PZ21-00016 (ZC) Planning Comments

PZ21-00016 (DEV)
Chocolatree (Comprehensive)
12/9/21

Letter of Intent - Addendum - Responses
Re Zone of 20 View Dr and 35 Inspirational Dr
Parcel# 408-07-026D

DRAWING TITLE:
 SITE PLAN AND PROJECT INFO
 CITY OF SEDONA COMMUNITY & ECONOMIC DEVELOPMENT

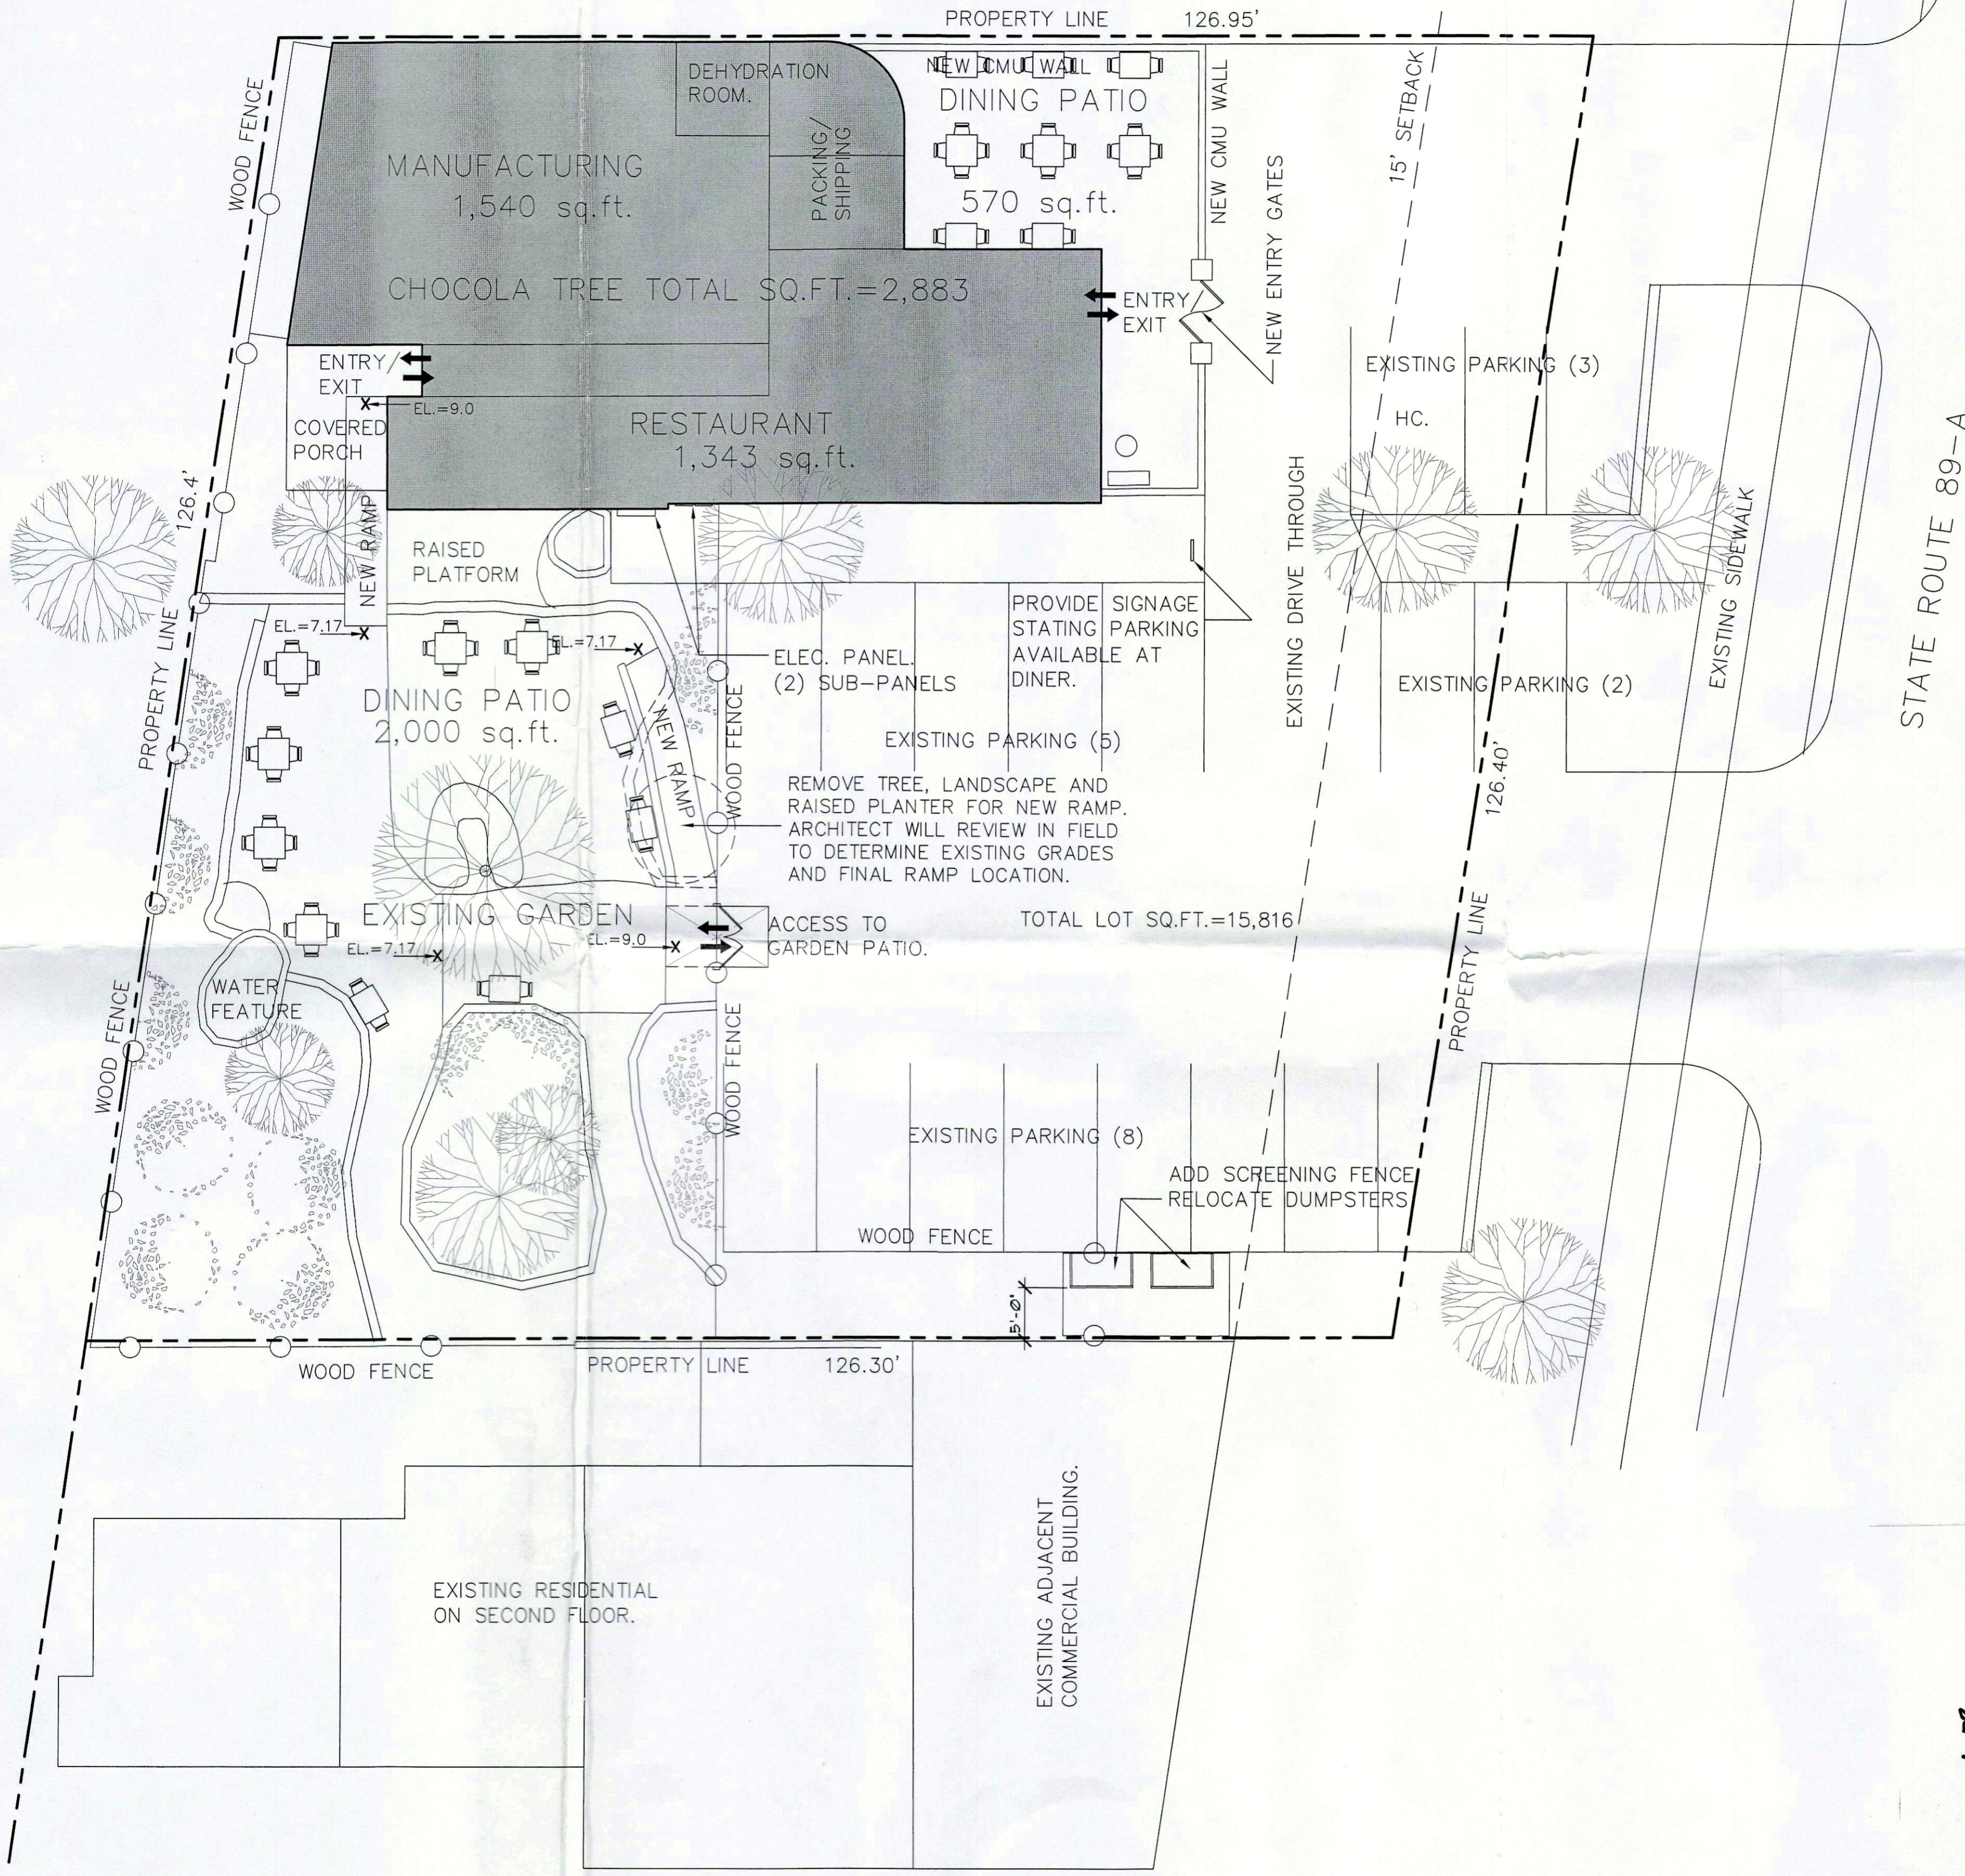
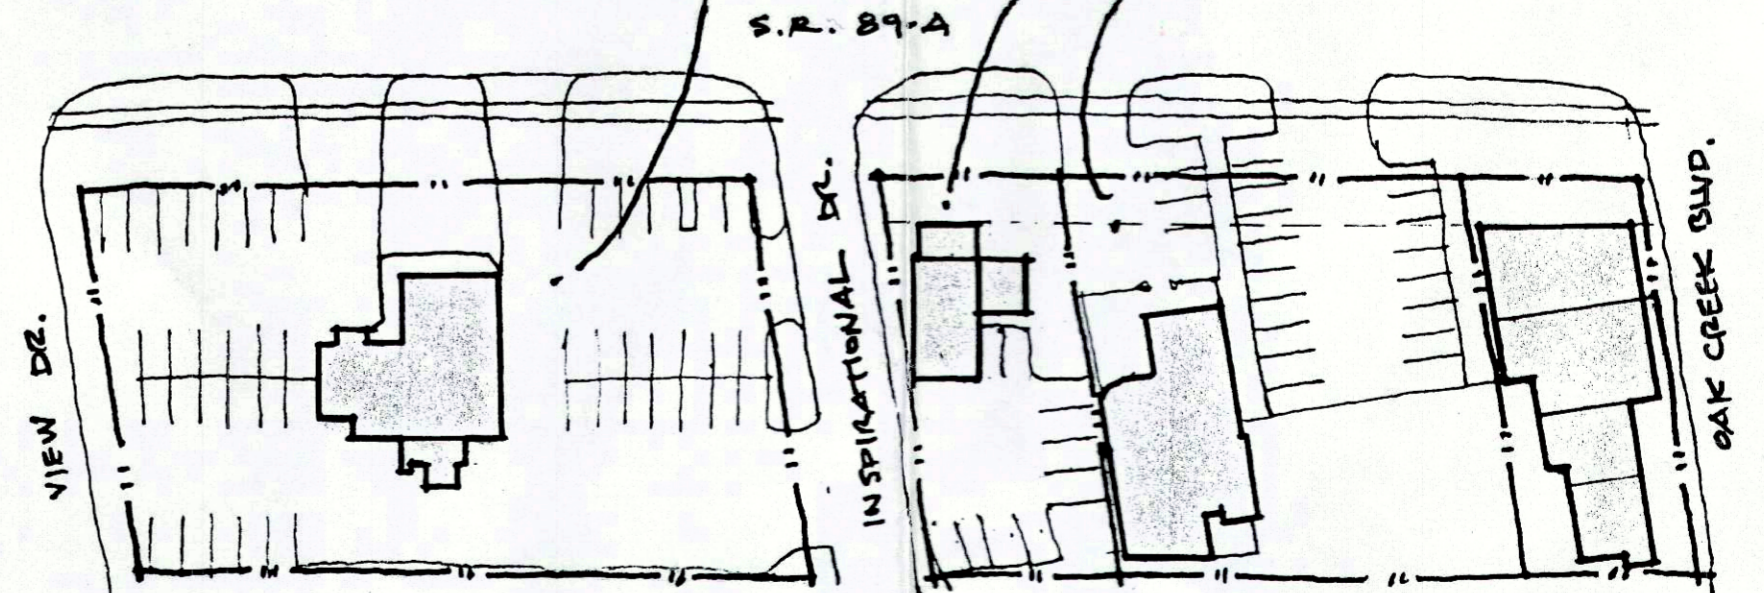
4. Letter of Intent (LOI)
 - a) Provide parking calculations for Chocolatree. Indicate whether the proposed parking will be used to accommodate existing demand or to allow for expansion of the restaurant.

1. noted
2. noted
3. noted
4. Letter of Intent - Addendum
 - a) The proposed parking will accommodate existing demand and provide extra in the case that we are to extend seating either indoors or out. – Please reference document attached named “4a current chocolatree parking calculations”.

3. Compact spaces must be signed and mounted 5' above grade. See "11a.b.c. Preliminary Parking Signage Plan."
4. The new ADA space to be at existing ChocolaTree parking lot adjacent to existing ADA space shown on drawing "4a current chocolatree parking calculations"

5 20 View Dr Residence Existing Plan

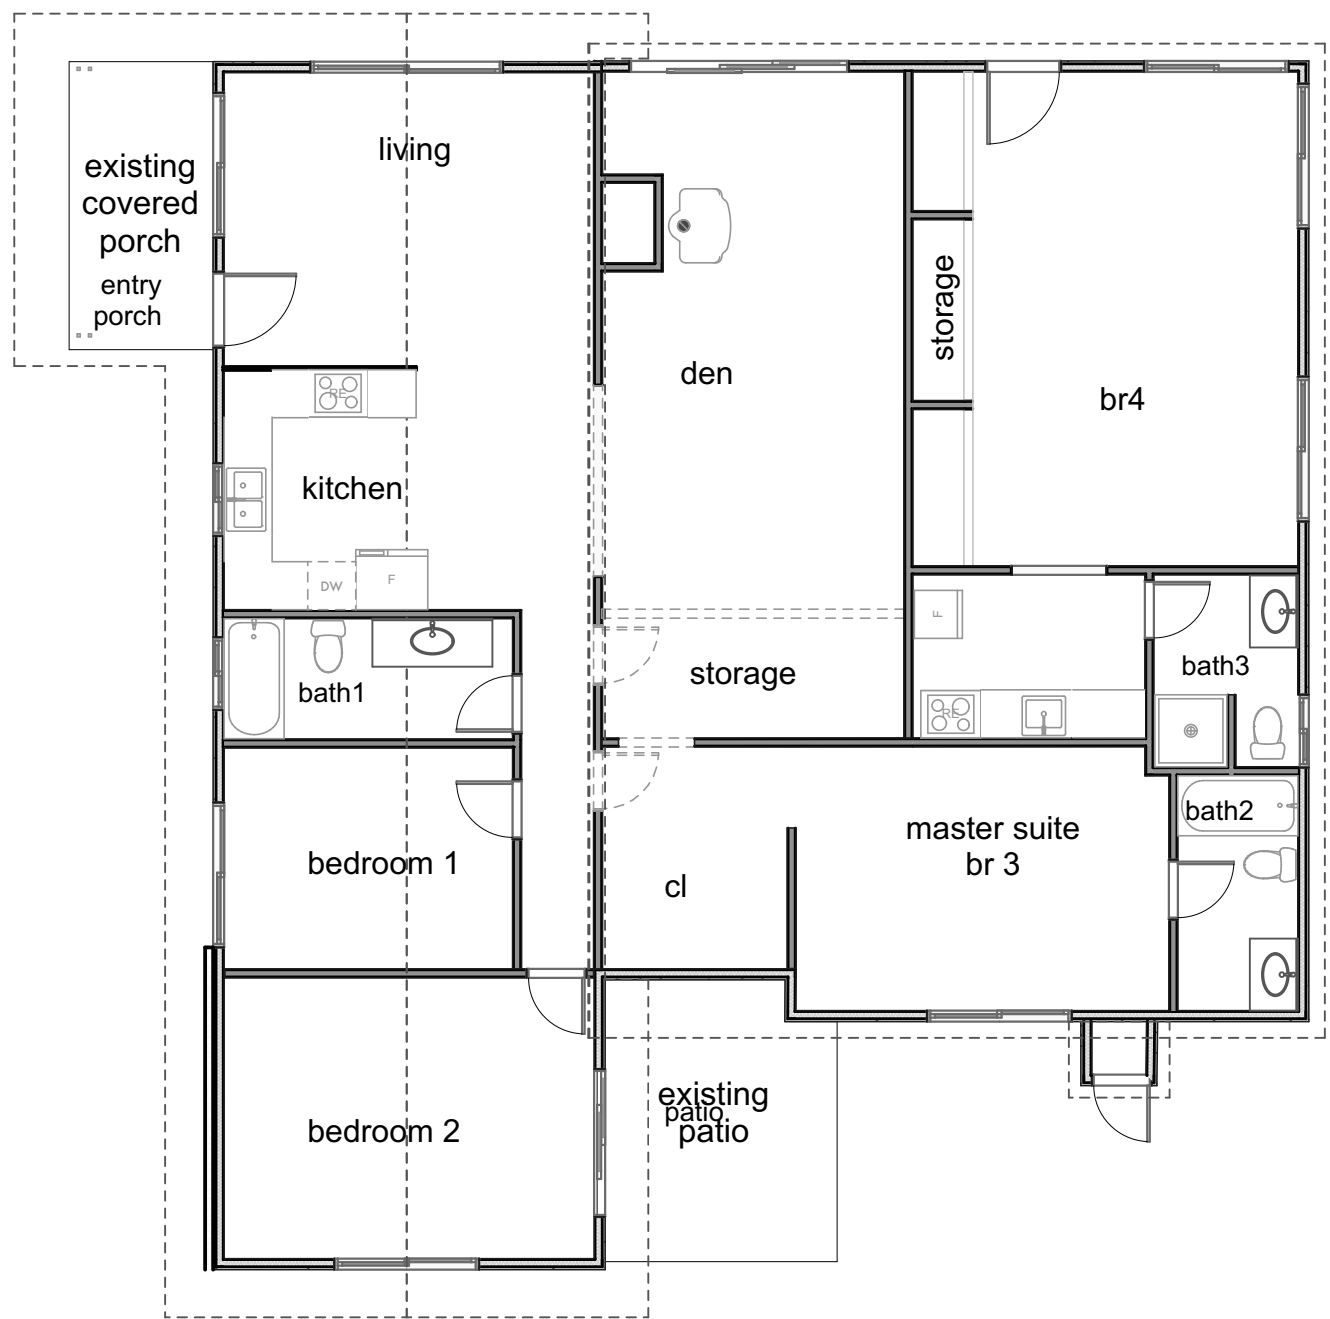
7. House on View Drive – Proposed to be converted to “M3 compliant residence and office”
 - a) Provide an explanation of how the house will be converted to become “M3 compliant”.

- b) Provide a timeline for this conversion – the LOI only states the conversion will begin within 1 year; provide anticipated completion date.
 - c) Provide a detailed floor plan of the house and a summary of the work needed for the conversion.

a. explanation of how the house will be converted to become “M3 compliant is shown in “7a. A-1 Existing 20 View Drive House Plan and Elevations.pdf” and document “7a. A-2 Demo and Proposed 20 View Plans.pdf” .Will consult with Building, Fire and Public Works officials and an architect to determine modifications necessary to convert 20 View from residential to M3 multifamily / commercial uses.

c. Detailed floor plan of the house is addressed in 7a. Summary of the work needed for the conversion in “7c summary of work.”

1 Preliminary Parking Landscape Plan

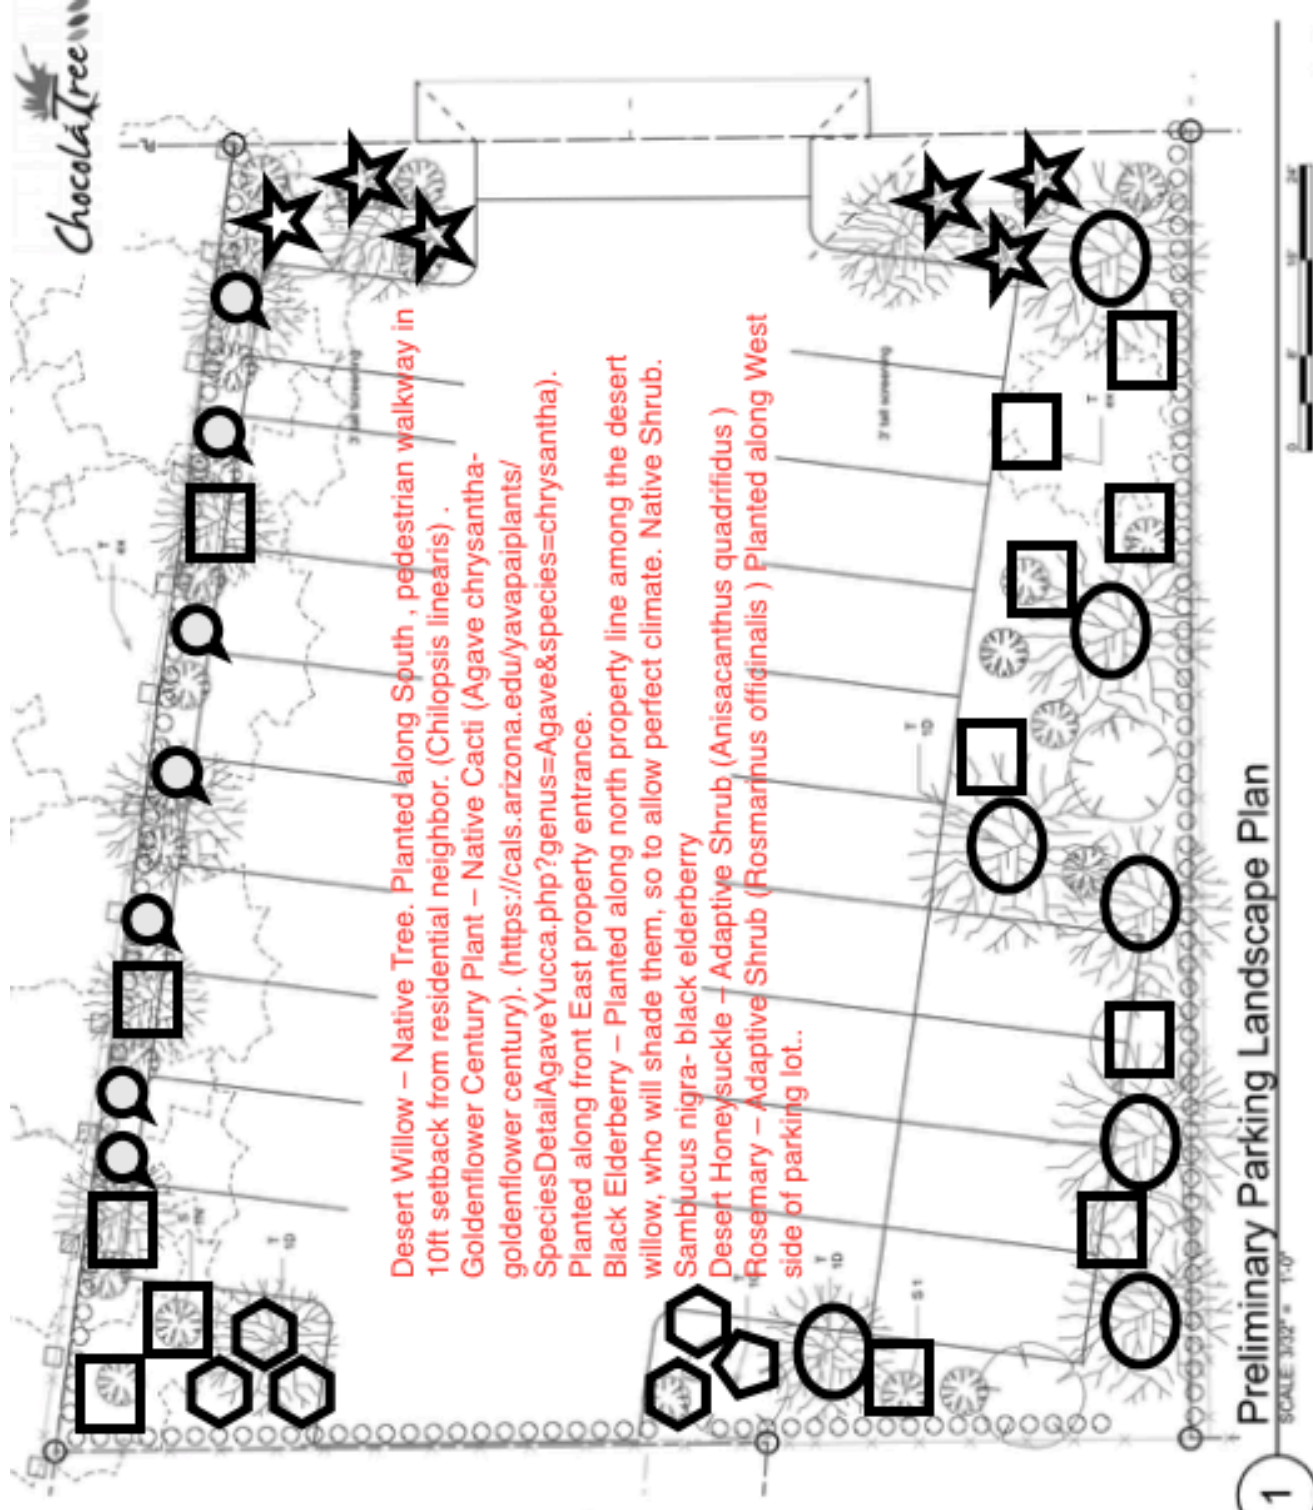
- b) Provide scientific name for each proposed tree and shrub. All plants must be included on the City’s plant list or determined to be suitable for the Sedona area.

- c) Provide proposed numbers of each tree and shrub.
 - i) A minimum of 1 tree and 3 shrubs per 400 square feet of landscape area are required. (LDC Section 5.6.C(1)a.2).

b) 9. Preliminary Parking Landscape Plan

c) 9. Preliminary Parking Landscape Plan
